ADDENDUM NO. 2

for
**PUBLIC ADDRESS AND CLOCK SYSTEM REPLACEMENT AT VARIOUS
MANALAPAN-ENGLISHTOWN REGIONAL SCHOOLS**
School, 118 Millhurst Road, Manalapan, NJ 07726

Issued: May 1, 2026

FVHD PROJECT NO. 5618

Drawing Number
E001

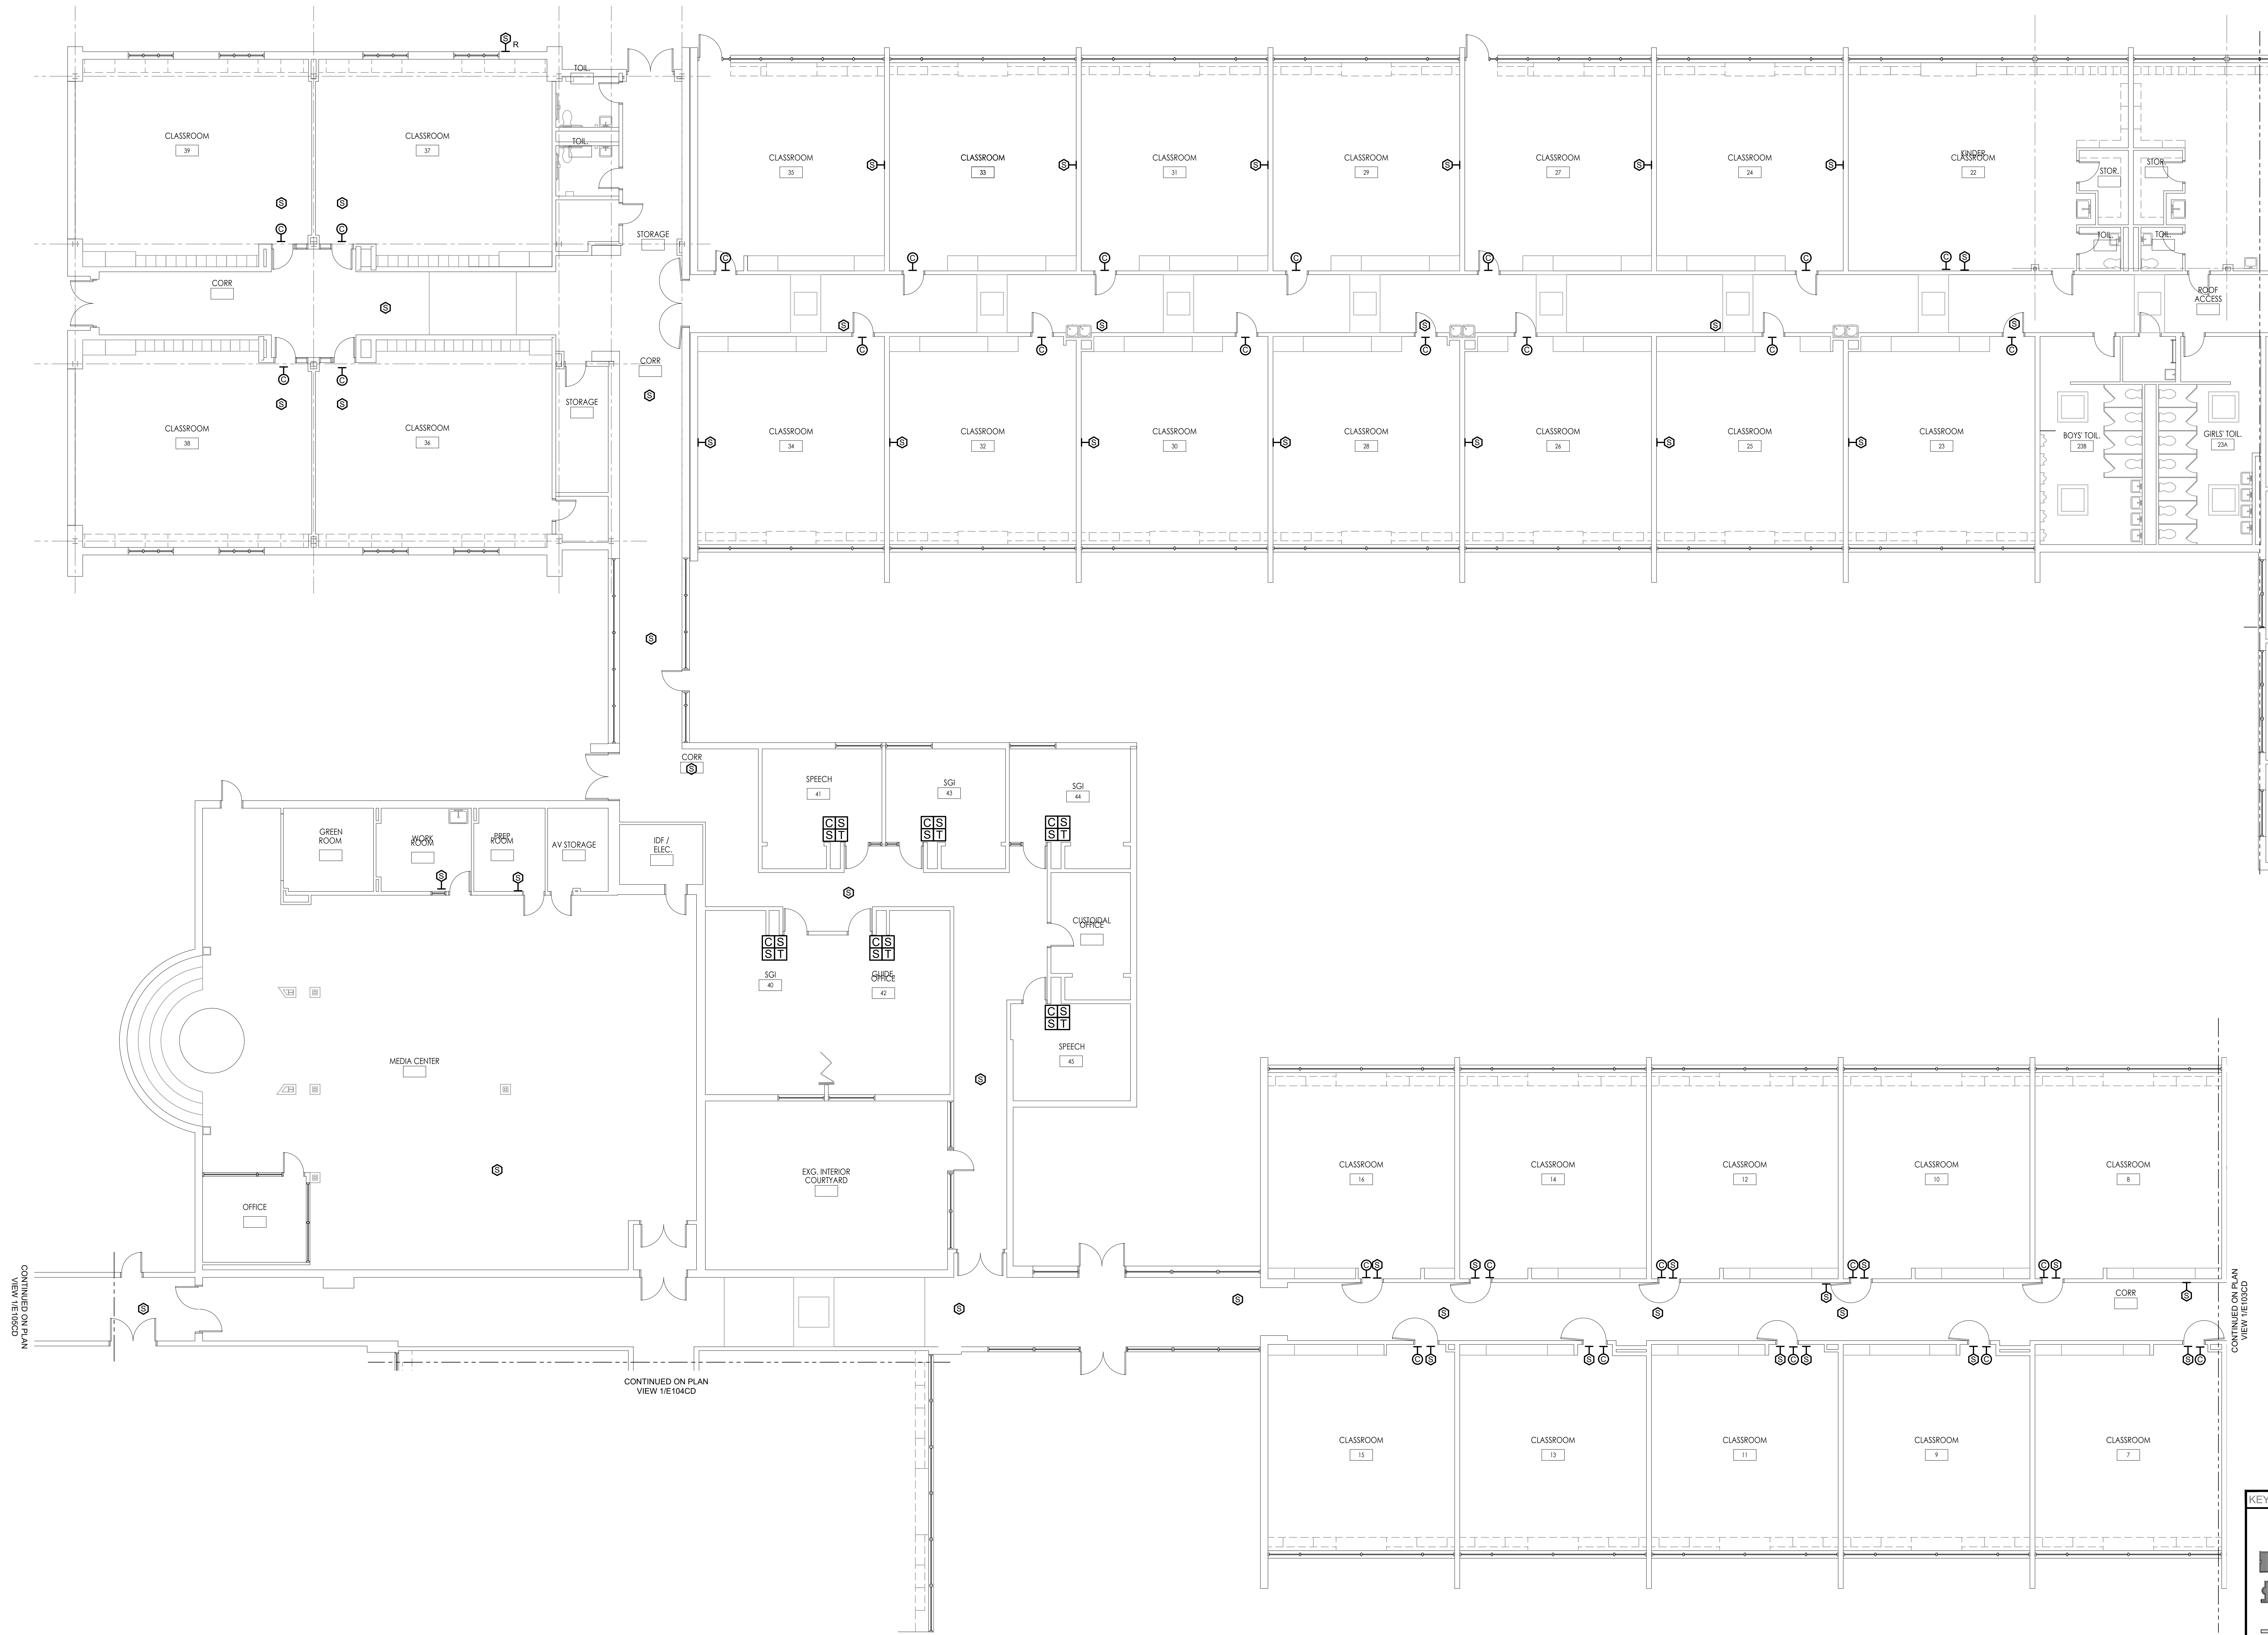
- 2.1.1 Drawing E001:
 - 2.1.1.1 Changed provisions for additional equipment included in General Notes 15, 16, 17, and 18 as shown on the attached drawing.

- 2.1.1.2 Modified Symbol Legend, General Notes and Abbreviations as indicated.
- 2.1.2 Removed Clark Mills Drawings E101CM, E102CM, E103CM, E104CM, E201CM, 202CM, 203CM, 204CM, and E601CM.

Drawing Number
E601CD

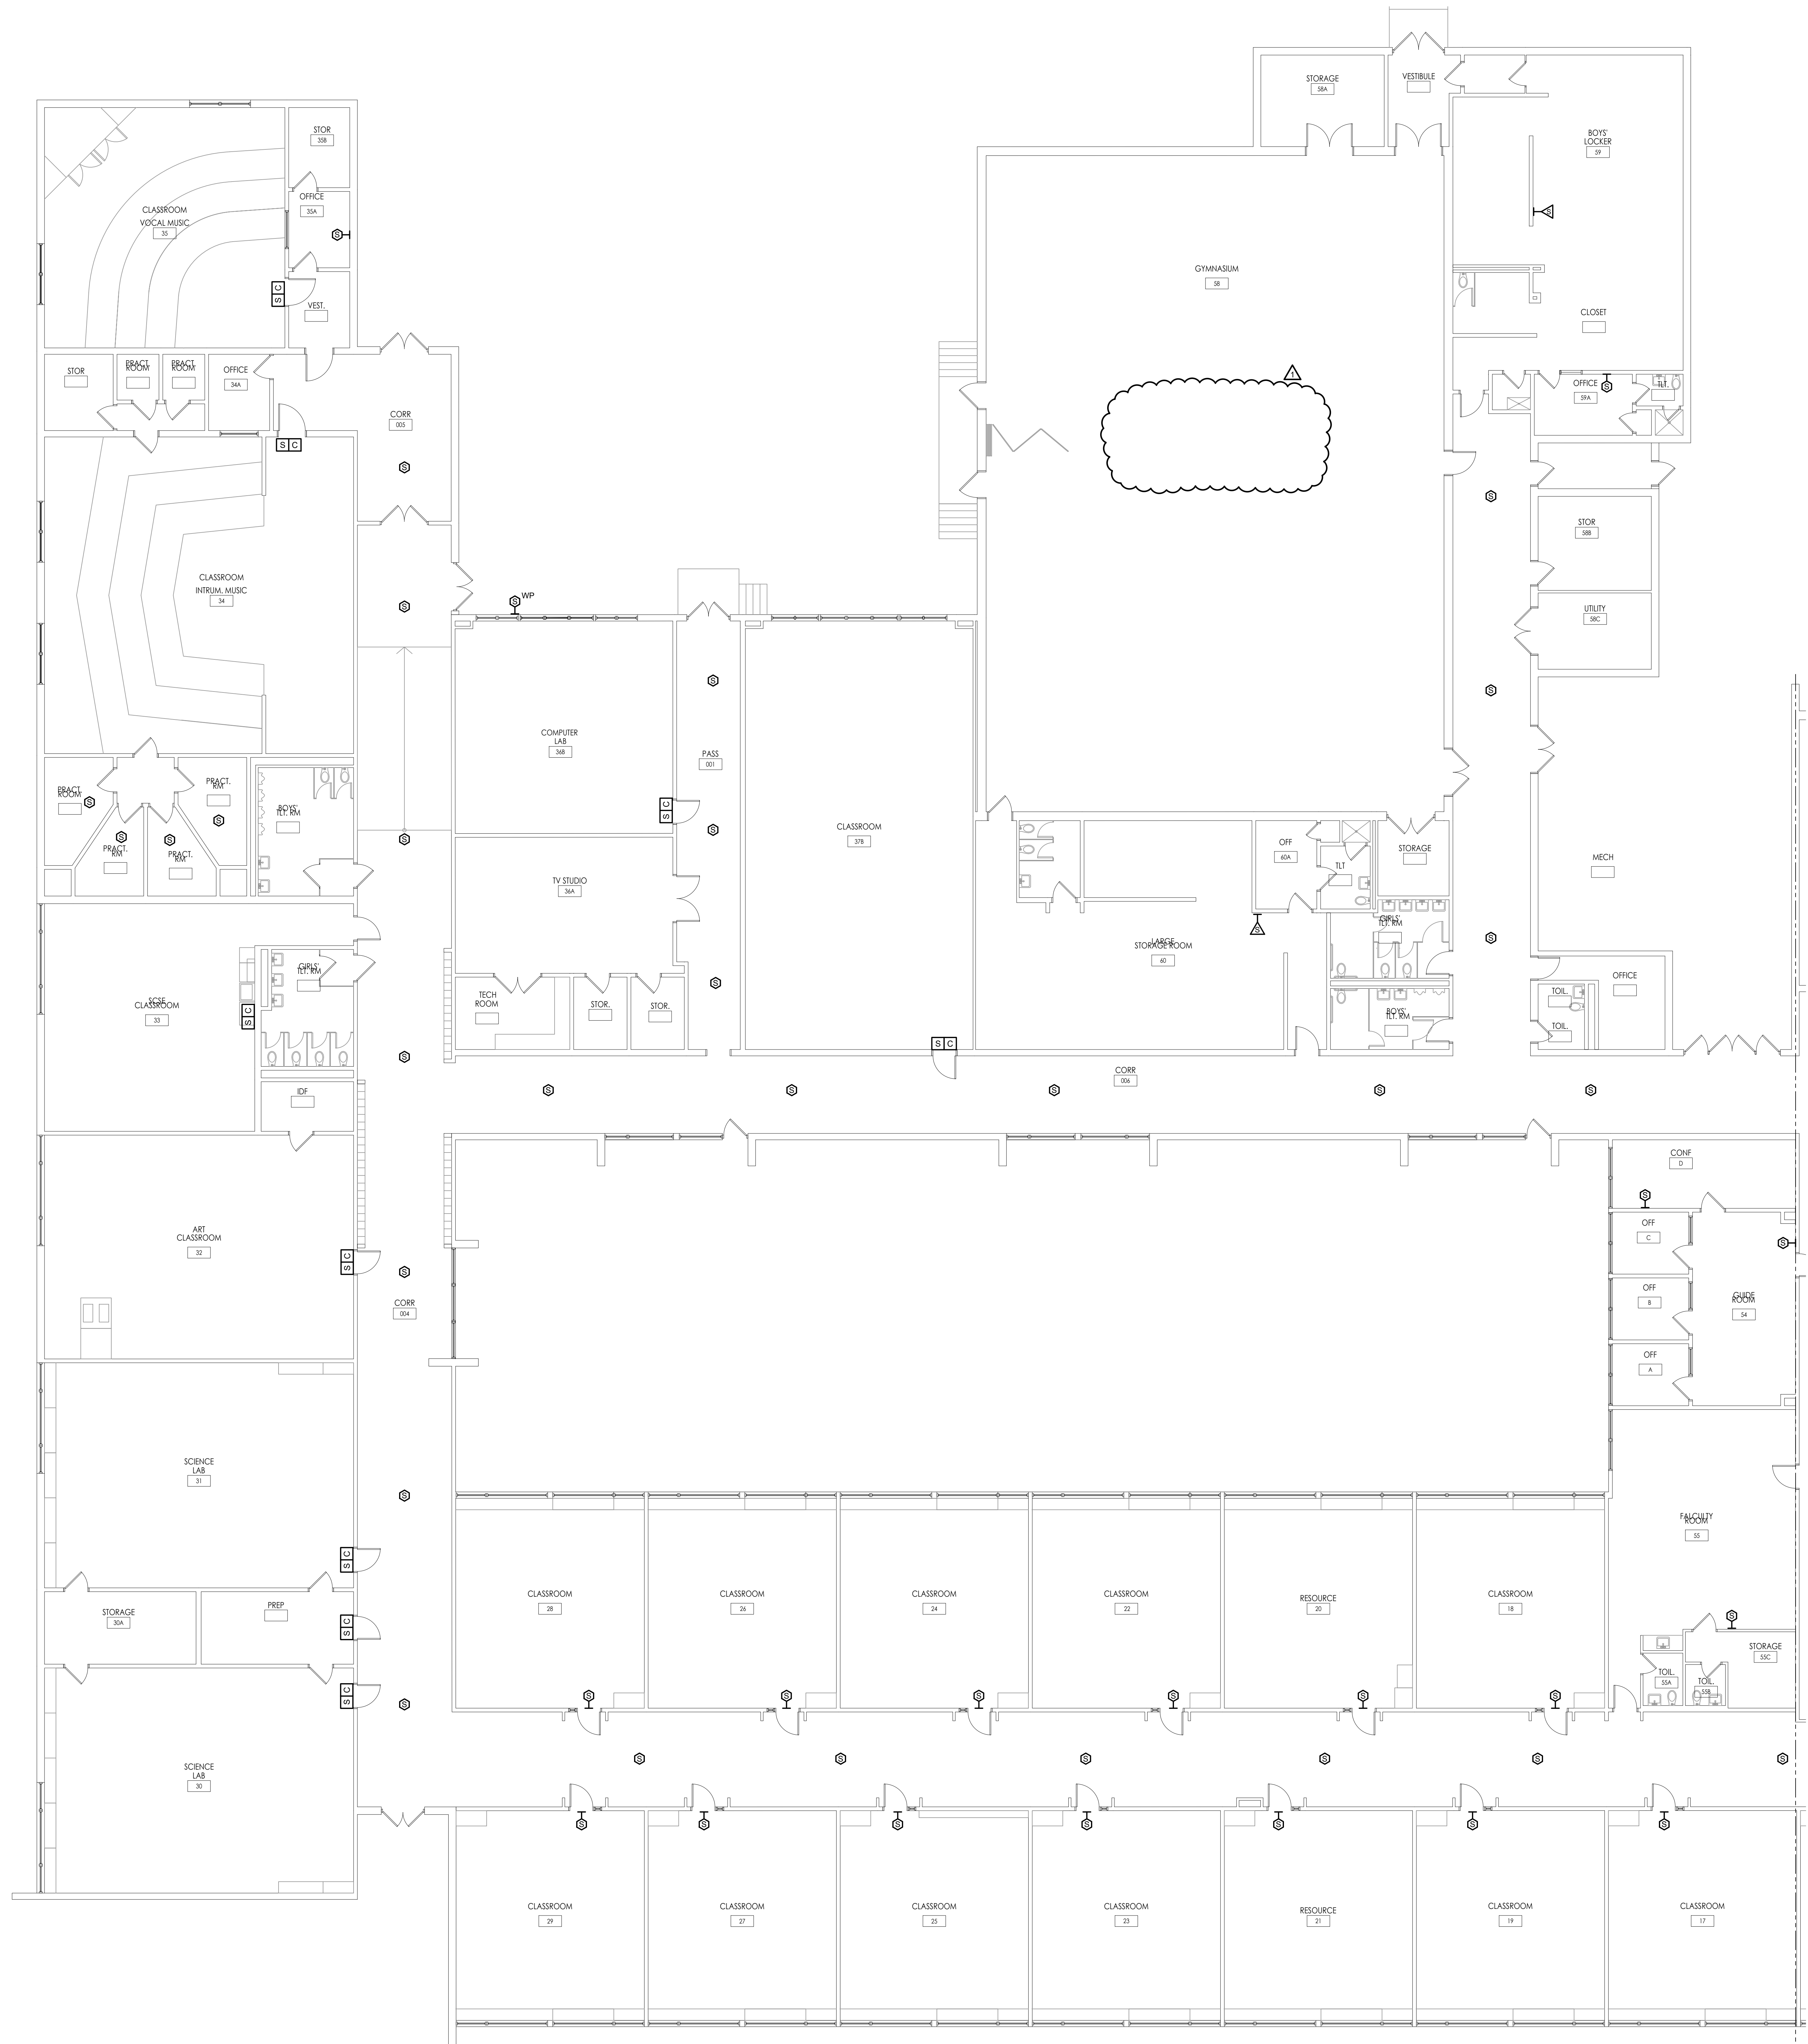
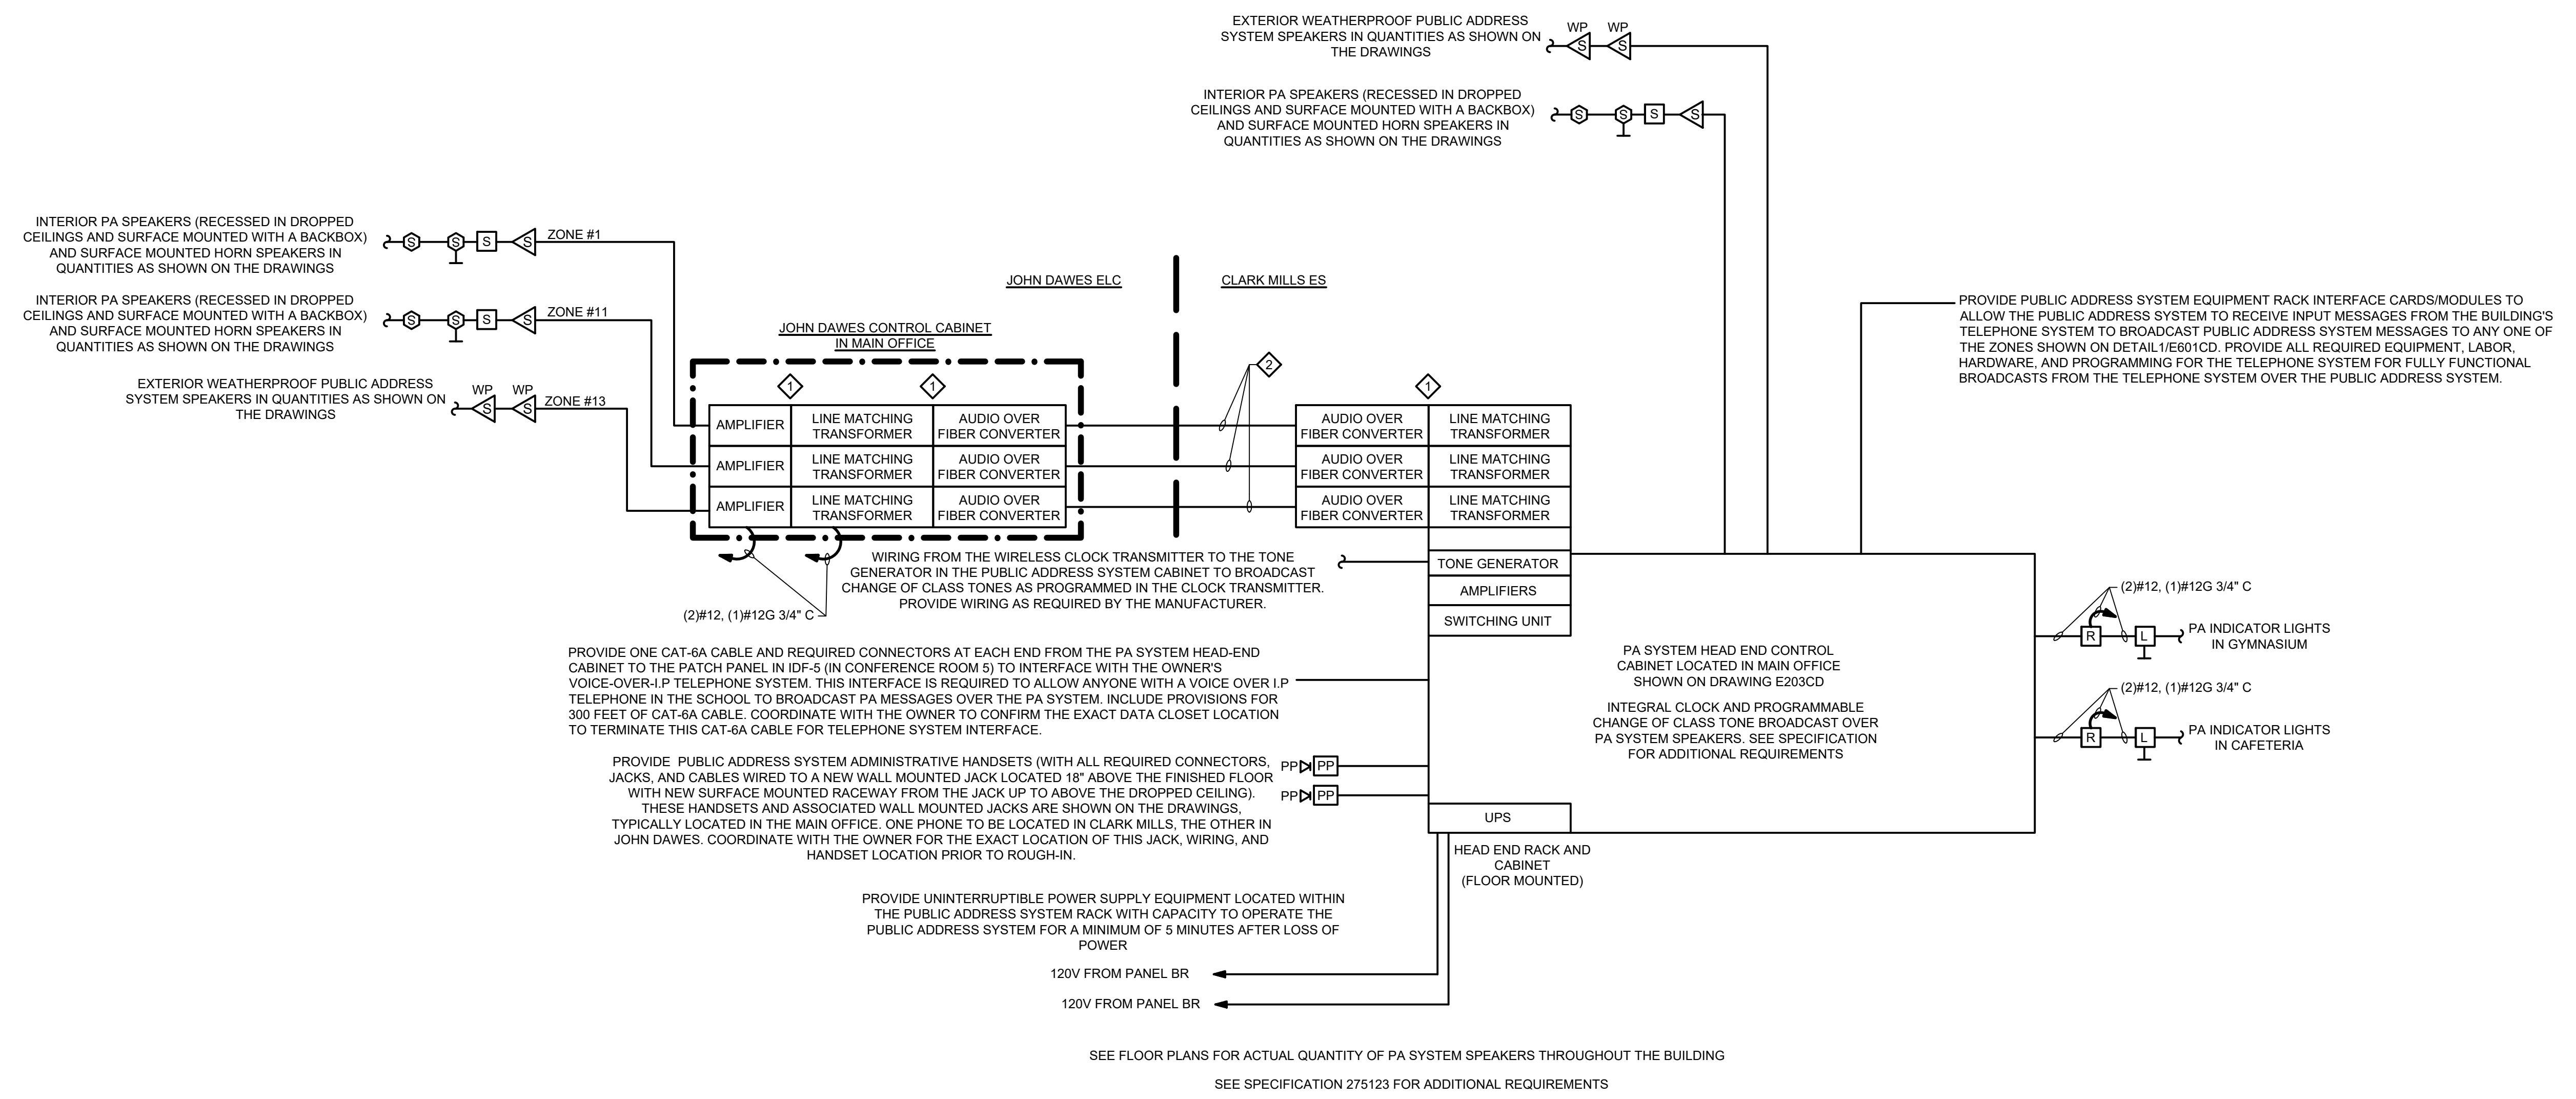
THE AUTHORITY HAVING JURISDICTION WILL NOT ALLOW 75 VOLT ANALOG WIRING TO BE EXTENDED BETWEEN THE FIRE RATED SEPARATION BETWEEN THE JOHN DAWES SCHOOL AND THE CLARK MILLS ELEMENTARY SCHOOL. THE 70 VOLT ANALOG WIRING FOR THE JOHN DAWES PUBLIC ADDRESS SPEAKER ZONES #1 AND #11 AND THE ANALOG HANDSET LOCATED IN THE JOHN DAWES MAIN OFFICE SHALL BE CONVERTED FROM 70 VOLT ANALOG TO A LINE LEVEL AUDIO SIGNAL (USING A 70 VOLT LINE MATCHING TRANSFORMER) AND THEN CONVERTED TO AN OPTICAL FIBER SIGNAL (USING AN AUDIO OVER FIBER CONVERTER) THAT SHALL BE CONNECTED TO A FIBER OPTIC CABLE SINGLE MODE OR MULTIMODE AS REQUIRED BY THE EQUIPMENT MANUFACTURER. THE FIBER OPTIC CABLE SHALL EXTEND FROM THE JOHN DAWES SCHOOL OVER TO THE CLARK MILLS SCHOOL (PROVIDE A FIRE RATED SEAL IN THE FIRE RATED SEPARATION BETWEEN THE JOHN DAWES SCHOOL AND THE CLARK MILLS SCHOOL). THE FIBER OPTIC CABLE SIGNAL SHALL THEN BE CONVERTED TO A LINE LEVEL AUDIO (USING AN AUDIO OVER FIBER CONVERTER). THE LINE LEVEL AUDIO SIGNAL SHALL BE CONVERTED TO 70 VOLT ANALOG (USING A 70 VOLT LINE MATCHING TRANSFORMER) AND THEN CONNECTED TO THE EQUIPMENT IN THE PUBLIC ADDRESS SYSTEM HEAD END CABINET IN THE CLARK MILLS SCHOOL.
